Product Change Notification

Change Notification #: 113817 - 00
Change Title: Intel® Server Chassis P4304CR2LFGN
 PCN 113817-00
 Product Design, Label
 Add new KCC certification logo to PSU label,
 Update the Safety label and Update Hard
 Disk Drive Tray to add 2 latches and labels
Date of Publication: April 23, 2015

Figure 1. Before Change

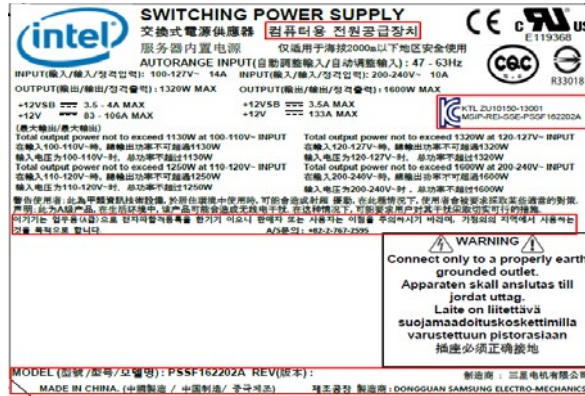
1. Product Label update: New KCC certification has been applied to Intel Power Supply Units. A new KCC logo is added to Power Supply Unit label. Please reference Label Example below.

Figure-1: Pre-Change

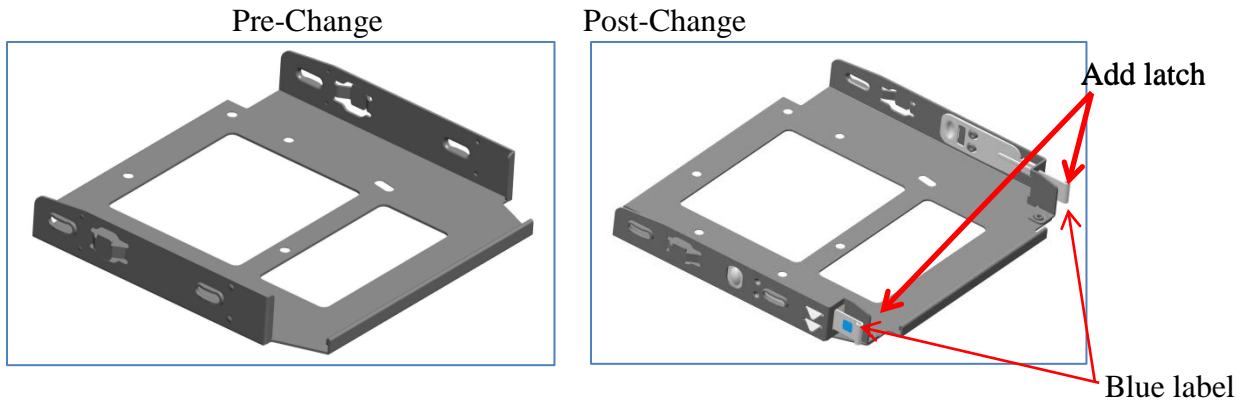
- Update the Safety Label: Put an EAC logo instead of a GOST logo for certification update. Please see Figure-1 and Figure-2 below for details.
